CITY OF ALBUQUERQUE

**RE: Geneivas Arroyo
CLOMR Request
Engineer's Stamp Date: 1-9-2026
Hydrology File: L15D006
Case # HYDR-2026-00007**

CLOMR REQUEST REPORT FOR GENEIVAS ARROYO

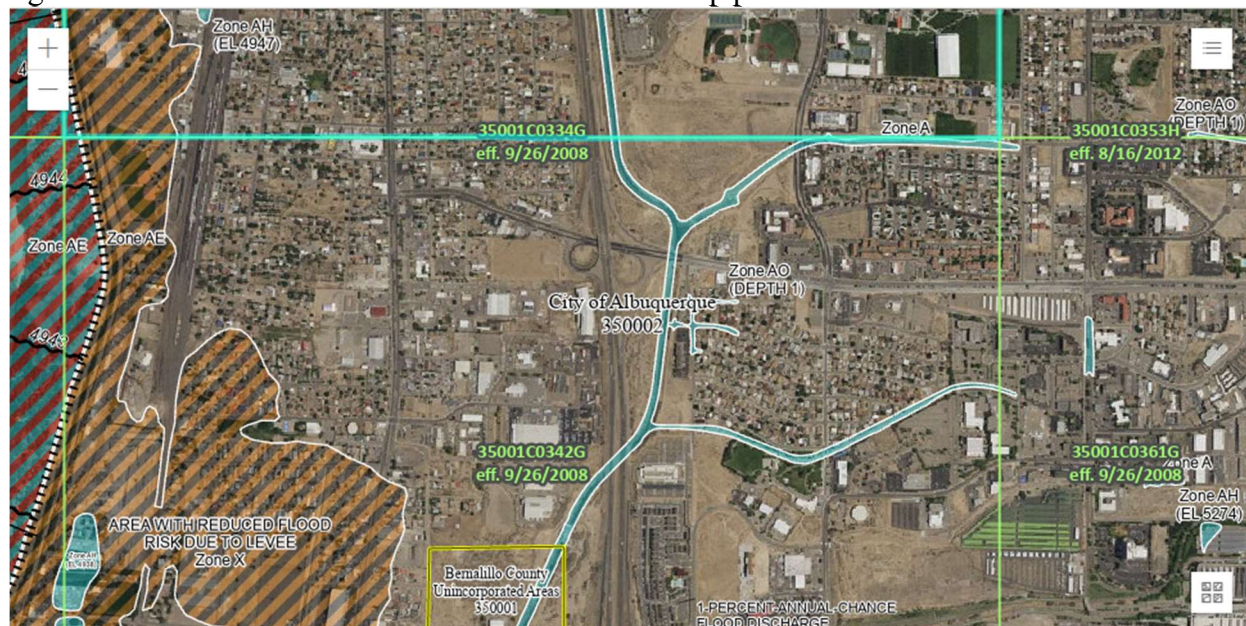
- Pg 14 of 65 - #1 – Split City and County on two lines. Make sure that the Panel numbers are all clearly shown.
